SUBJECT: **Request for Permit Modification of CAMA Major Development Permit** for the Proposed Replacement of the Lindsay C. Warren Bridge (Tyrrell County Bridge No. 7) on U.S. 64 over the Alligator River/Atlantic Intracoastal Waterway in Tyrrell and Dare Counties, North Carolina. STIP Project No. HB-0001; Federal Aid Project No. NHPB-0001.

REFERENCE: CAMA Major Development Permit, Permit No. 136-23. Issued November 30, 2023.

The purpose of this letter is to request modification of the existing CAMA Major Development Permit to include these activities. In addition to this letter, revised permit drawings showing test pile locations and impacts, mapping and a construction detail of mooring pile locations, and a construction detail of test piles are also included.

Bent #6 Test Pile
Sta. 51+62.00

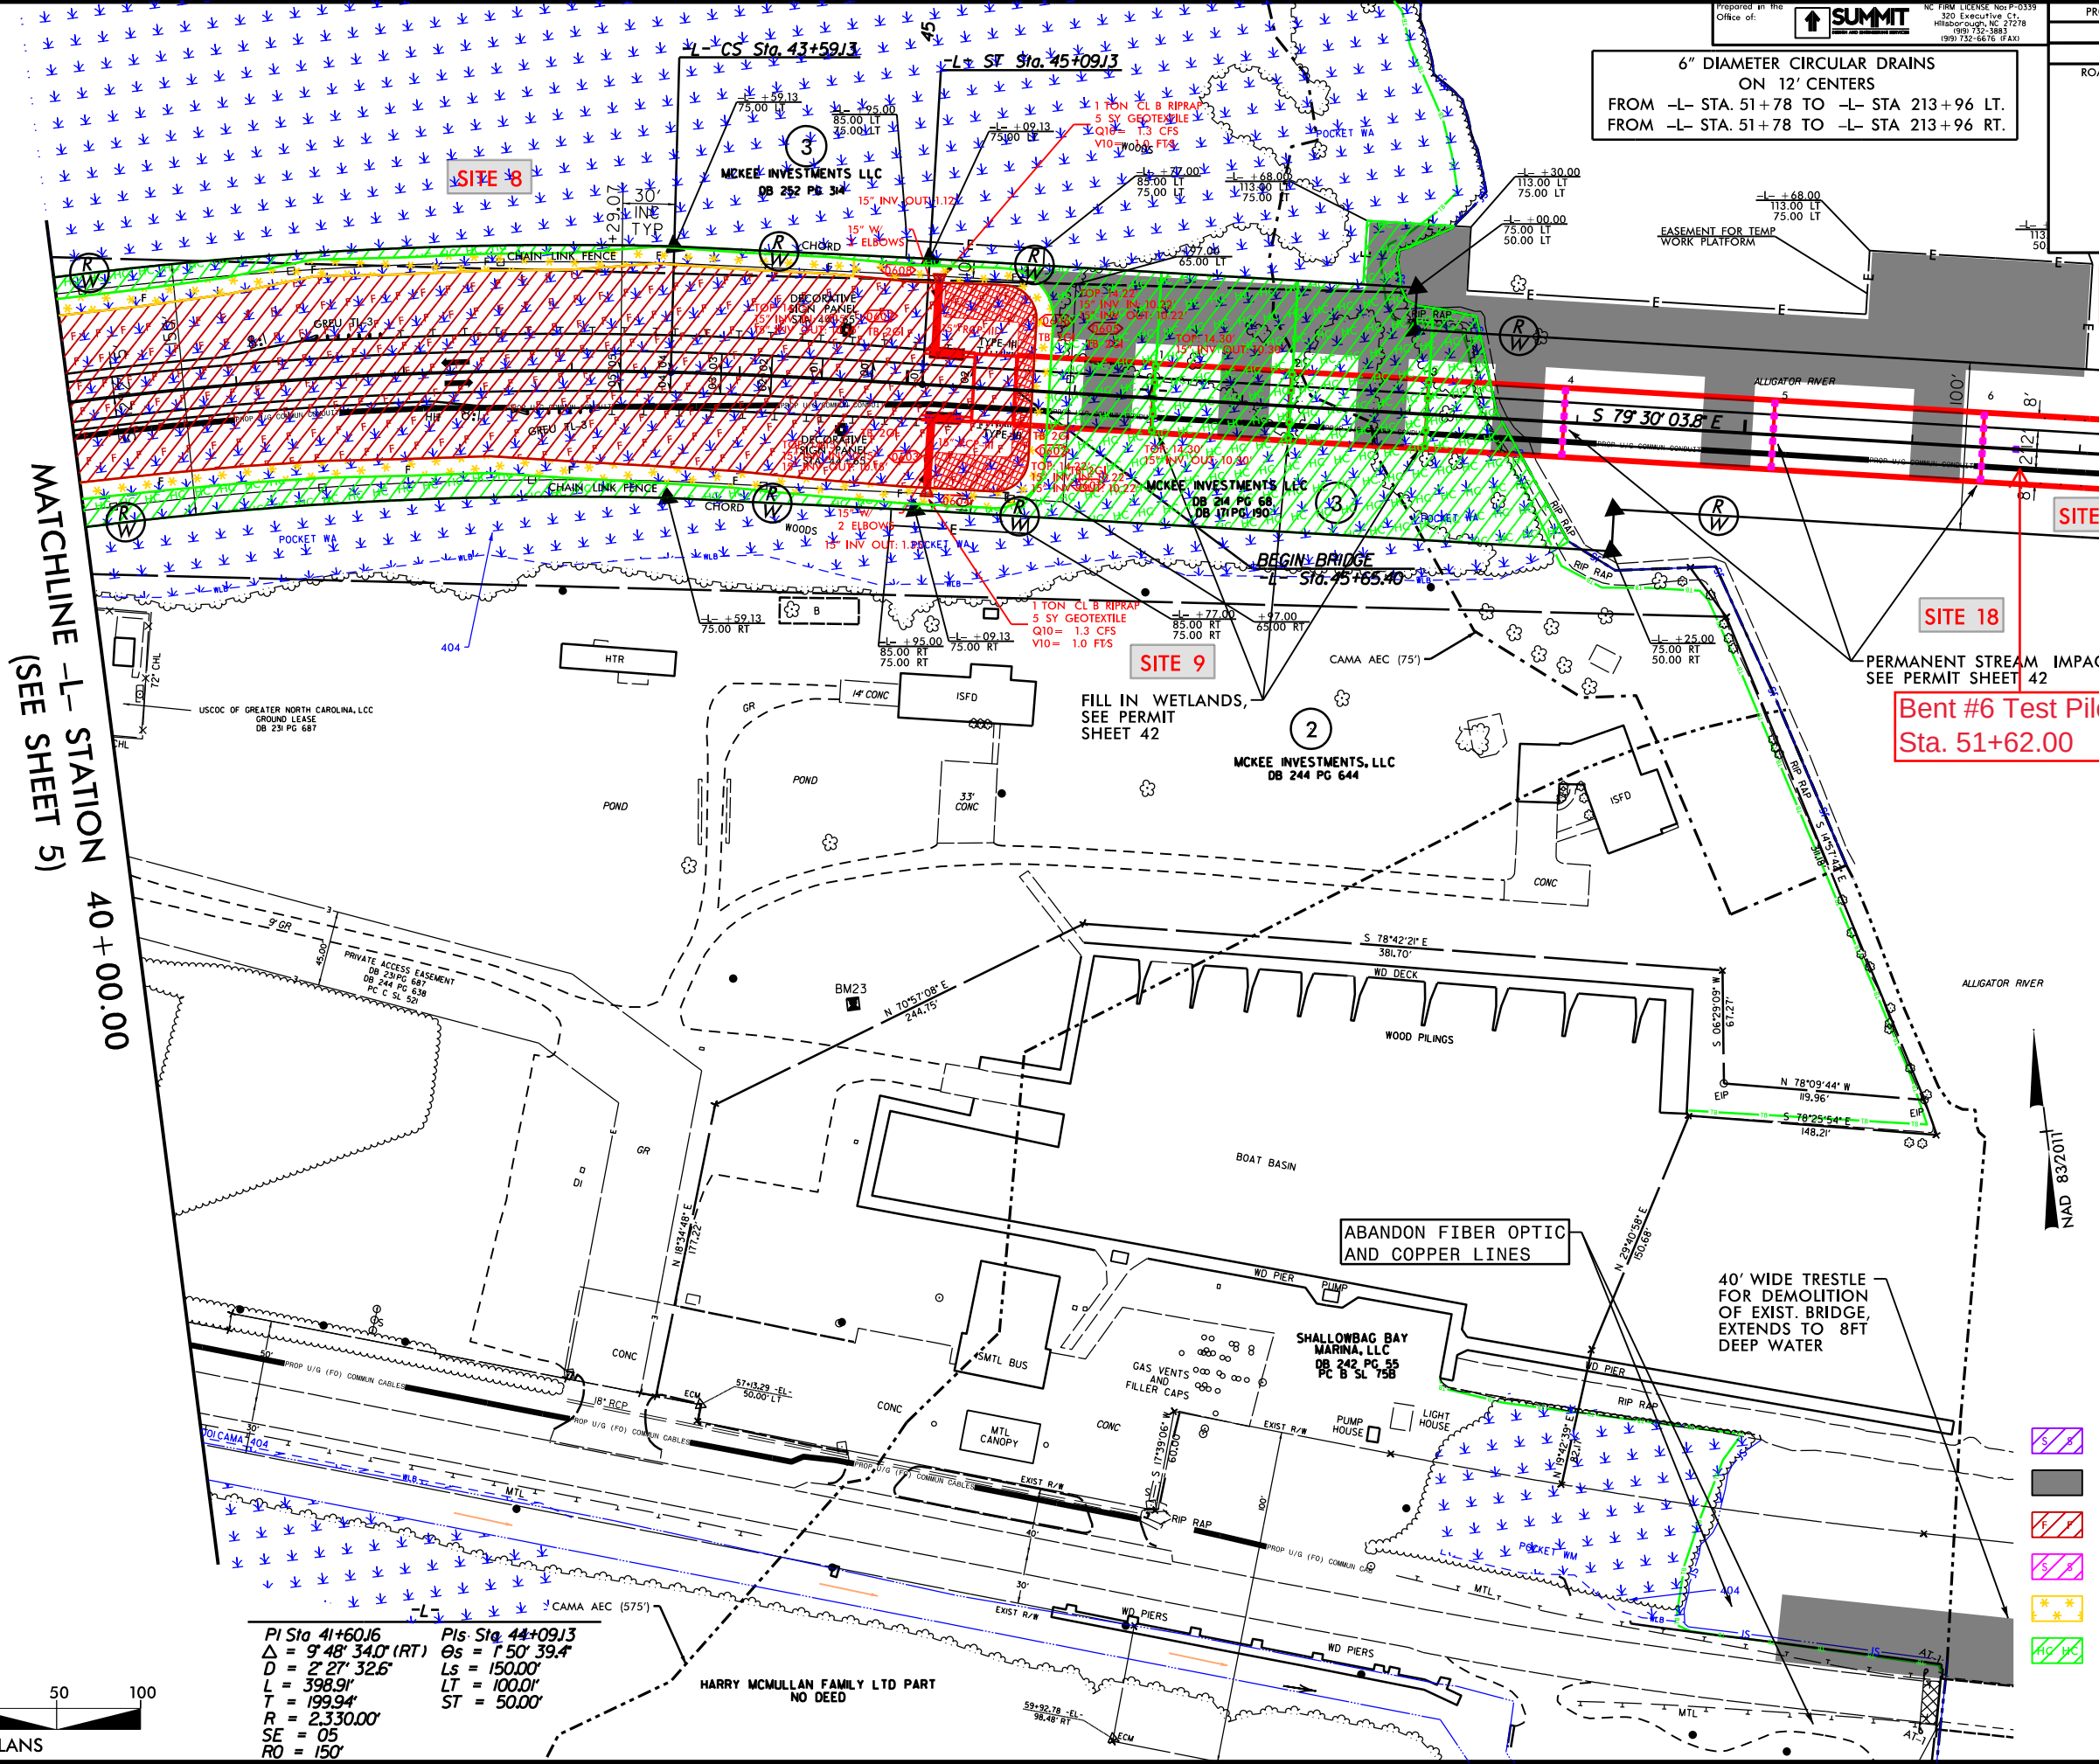
- **Bent 6:** 1 ea. 36" Pile Station 51+62 @ CL
- **Bent 8:** 1 ea. 36" Pile Station 54+12 @ CL
- **Bent 19:** 1 ea. 36" Pile Station 67+87 @ CL
- **Bent 30:** 1 ea. 36" Pile Station 81+62 @ CL

Bent #47 Test Piles
Sta. 106+13.25

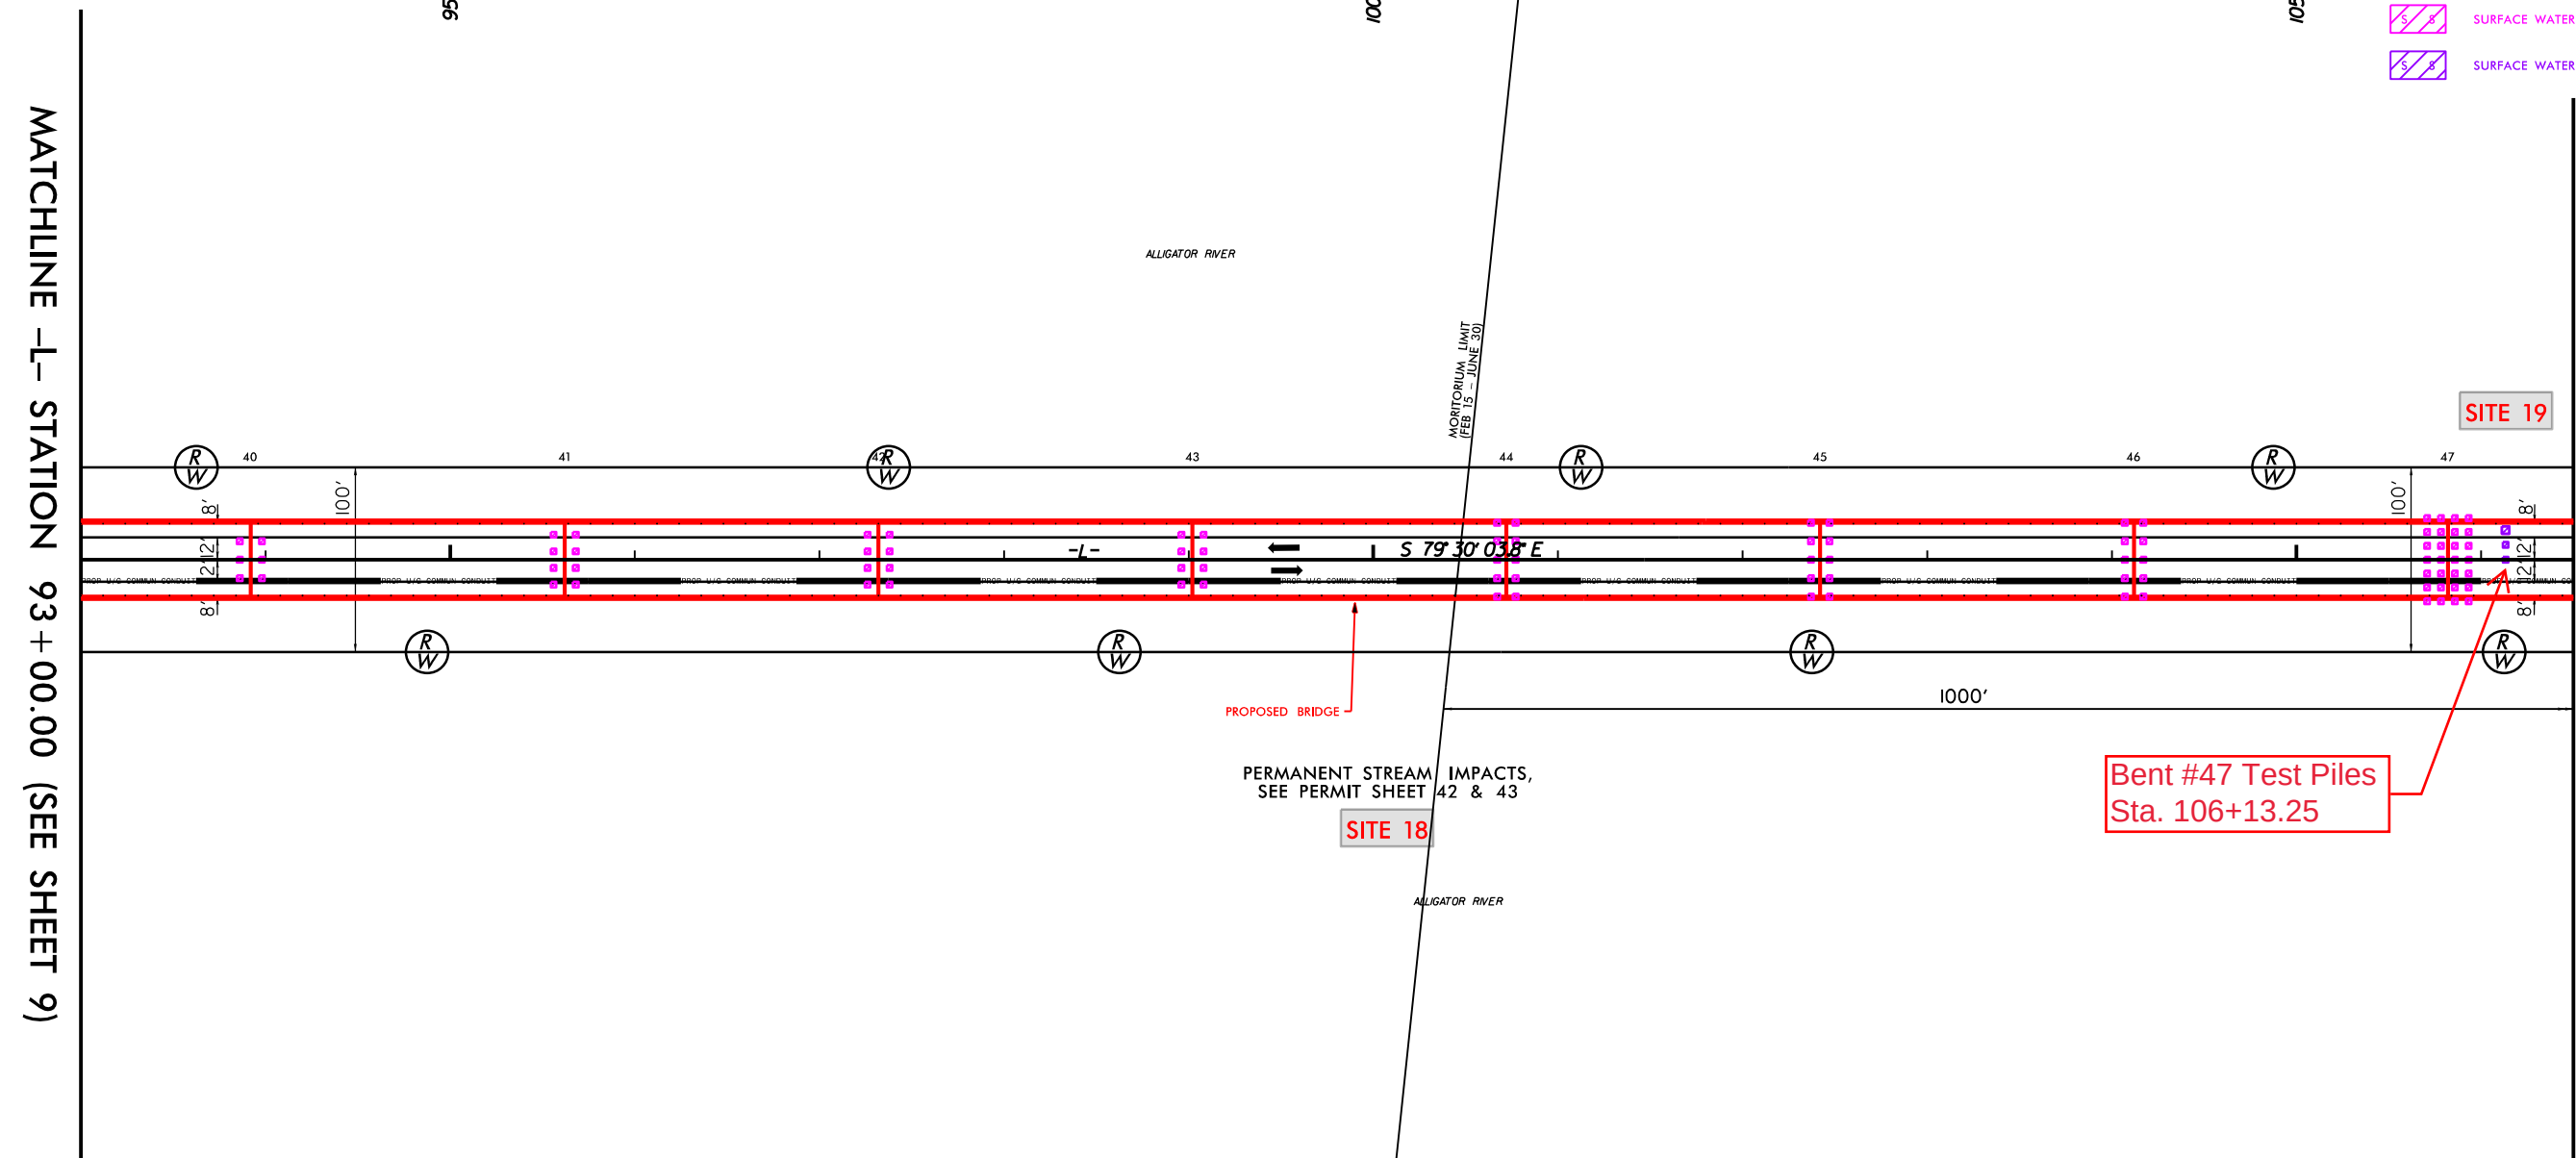
- **Bent 37:** 1 ea. 36" Pile Station 90+37 @ CL
1 ea. 36" Pile Station 90+37 @ 8' LT of CL
1 ea. 48" P-Pile Station 90+37 @ 16' LT of CL
- **Bent 47:** 1 ea. 36" Pile Station 106+13.25 @ CL
1 ea. 36" Pile Station 106+13.25 @ 8' LT of CL
1 ea. 48" P-Pile Station 106+13.25 @ 16' LT of CL

Bent #73 Test Pile
Sta. 144+82.00

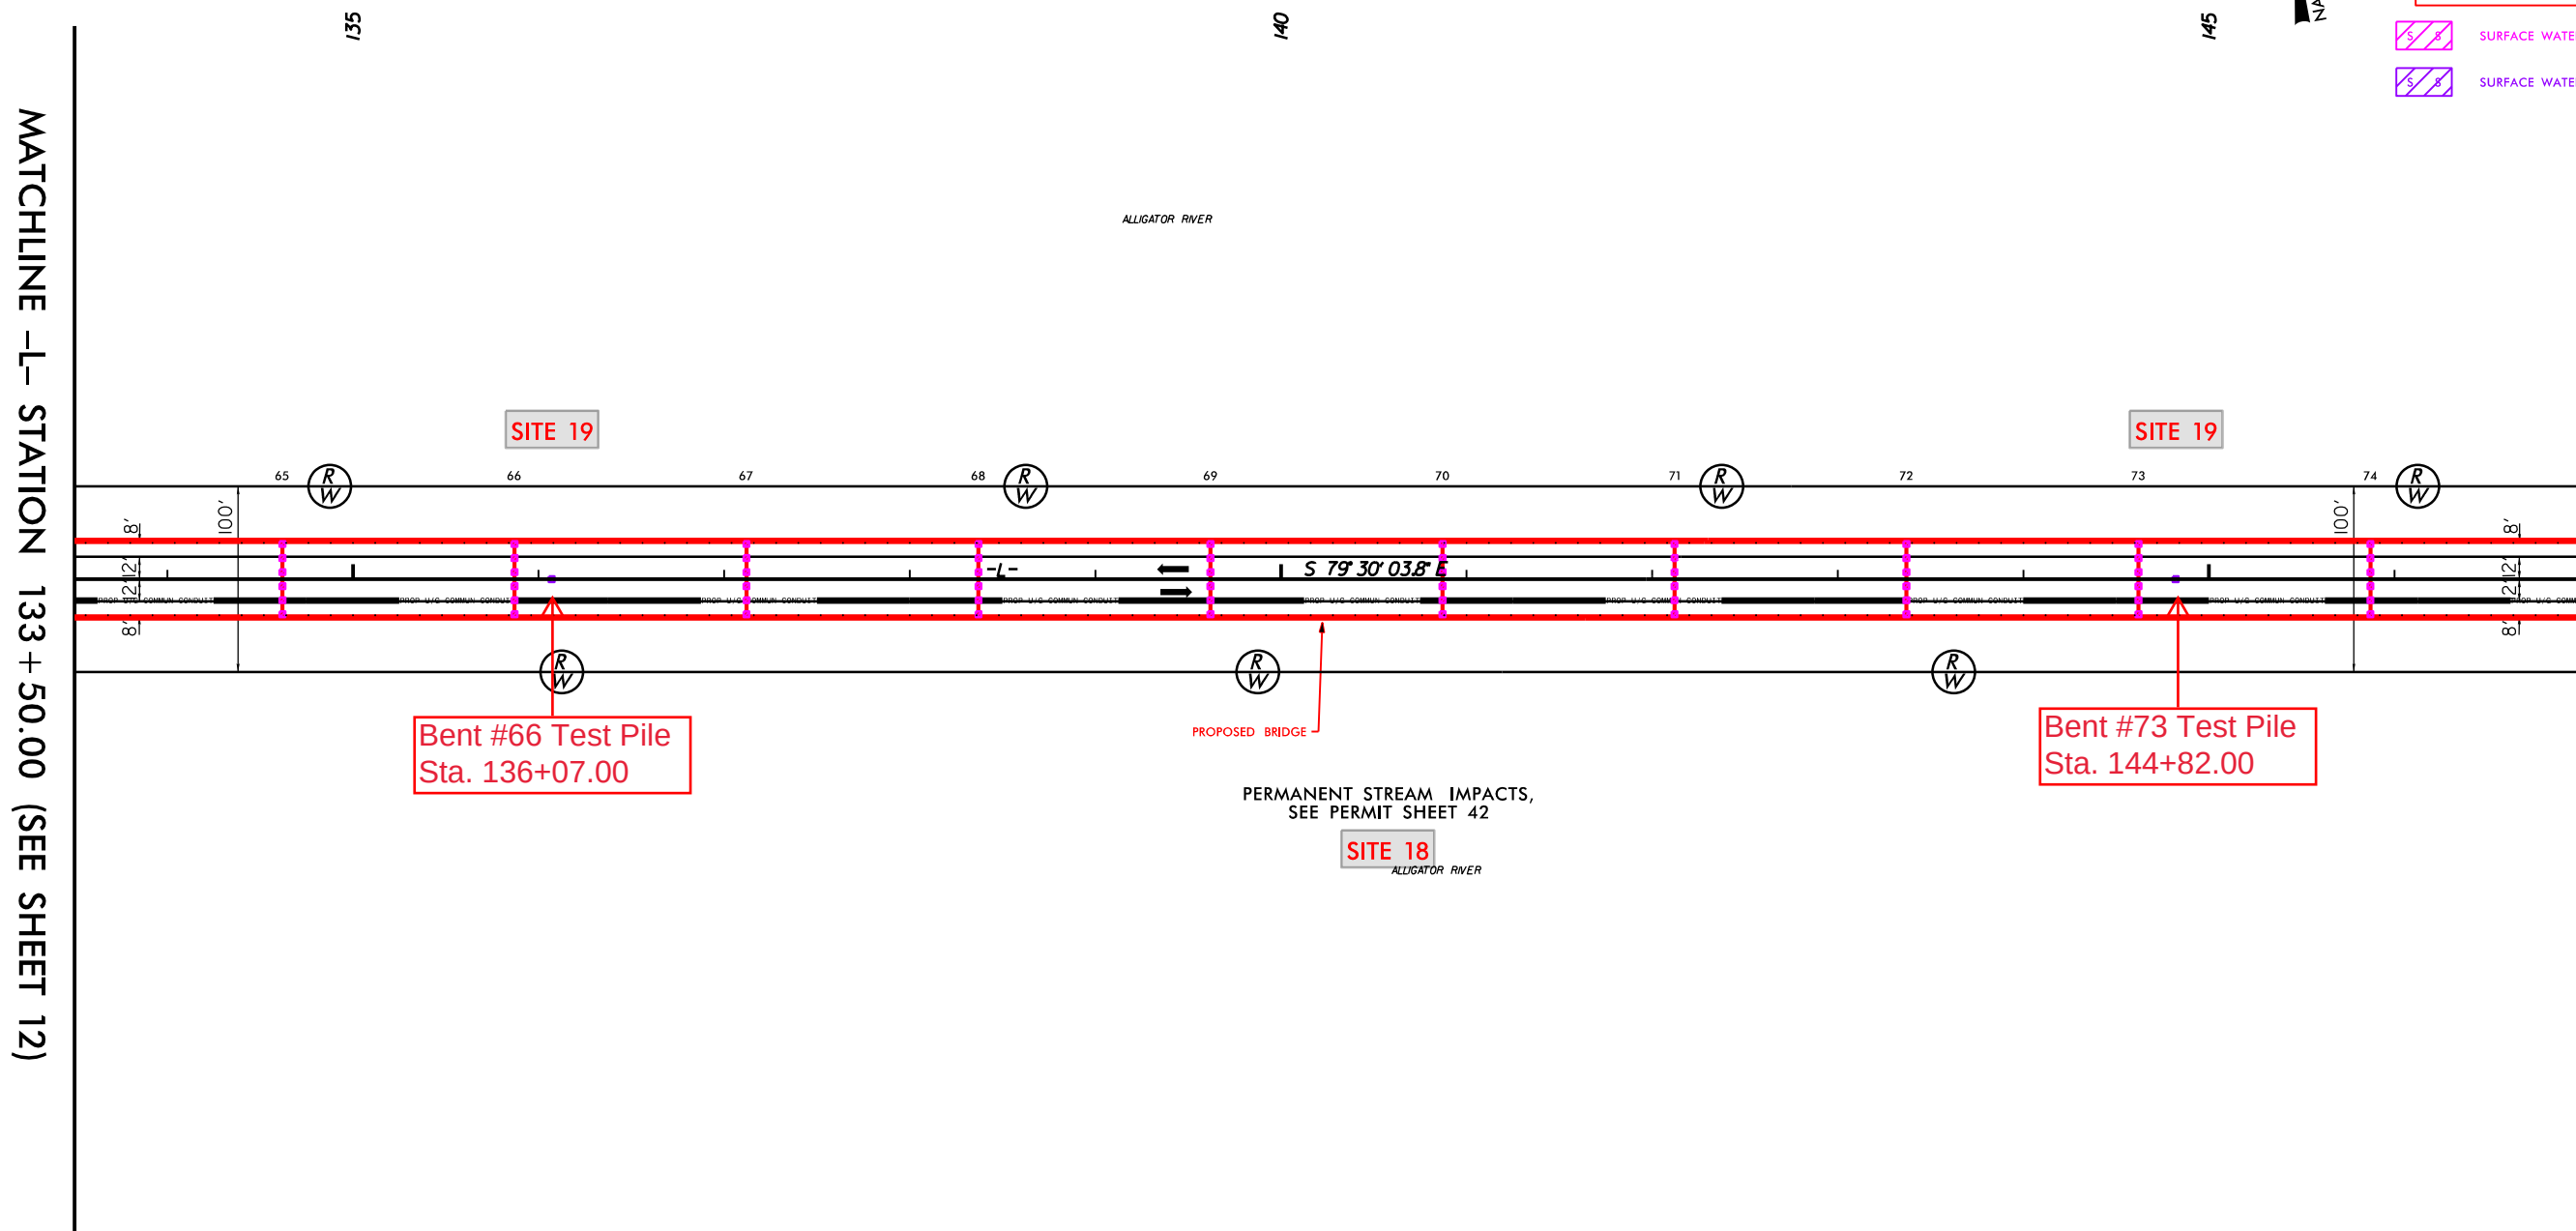
- **Bent 62:** 1 ea. 36" Pile Station 131+07 @ CL
- **Bent 66:** 1 ea. 36" Pile Station 136+07 @ CL
- **Bent 73:** 1 ea. 36" Pile Station 144+82 @ CL
- **Bent 91:** 1 ea. 36" Pile Station 167+32 @ CL
